**Item 10 SUBJECT: INLET MANIFOLD**

**Item 13 SUBJECT: SILL PANELS**

**Item 14 SUBJECT: DASH**

**Fig. 2 Location of mounting bracket for control panel**

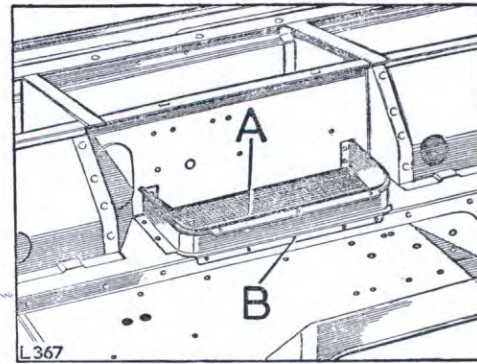
Each 4 cylinder dash is supplied with a mounting bracket for control panel and a blanking plate for control panel aperture. One or the other of these must be fitted to suit model applicability. See Fig. 2 and Fig. 3.

- A—Mounting bracket for control panel
- B—Retain with rivets, Part No. 78697, as indicated

**Fig. 3 Location of blanking plate for control panel aperture**

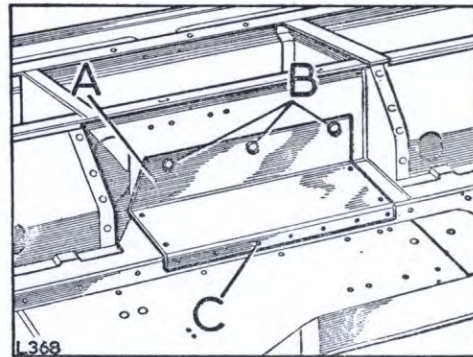
- A—Blanking plate for control panel aperture
- B—Retain with bolts  $\frac{1}{2}$  in. UNF x  $\frac{1}{2}$  in. long, spring washers and nuts
- C—Secure with rivets, Part No. 78697, as indicated

**Fig. 4 Bracket for finisher and rubber finishers for dash rail**

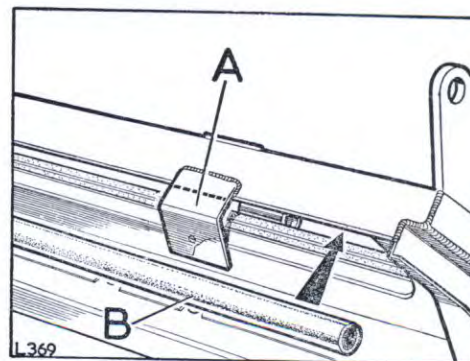
On all vehicles up to and including suffix 'C' remove outer bracket for dash rail finisher and fit rubber finisher for dash top rail. See Fig. 4.

- A—Remove bracket as indicated by dotted line
- B—Fit rubber finisher to edge of rail

**Fig. 5 Position of holes for windscreen wiper**

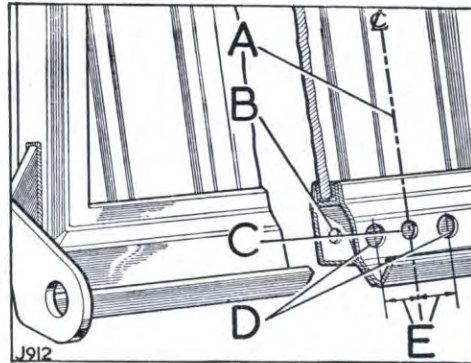
<b>Item 15</b>	<b>SUBJECT:</b>	<b>WINDSCREEN</b>
	<b>MODEL:</b>	Land-Rover Series II, IIA and IIB.
	<b>PART NUMBER:</b>	Windscreen complete assembly . . . . . 1 338266
	<b>REMARKS:</b>	Stocks of the early type windscreen, Part No. 330665, which were suitable for the early type windscreen wipers attached to the windscreen have now been completely exhausted. It is our intention to supply the later type windscreen, Part No. 338266, as a replacement for the early type, this can be used but it will be necessary to drill the windscreen frame as shown at Fig. 5 to enable the windscreen wipers to be fitted.

- A—Centre line of windscreen glass
- B—Drill two outer holes  $\frac{7}{32}$  in. (5,5 mm) in inner bottom rail of windscreen
- C—Drill centre hole  $\frac{1}{2}$  in. (9 mm) in both inner and outer bottom rails of windscreen
- D—Drill two outer holes  $\frac{7}{16}$  in. (11 mm) in outer bottom rail of windscreen
- E— $\frac{3}{4}$  in. (19 mm)
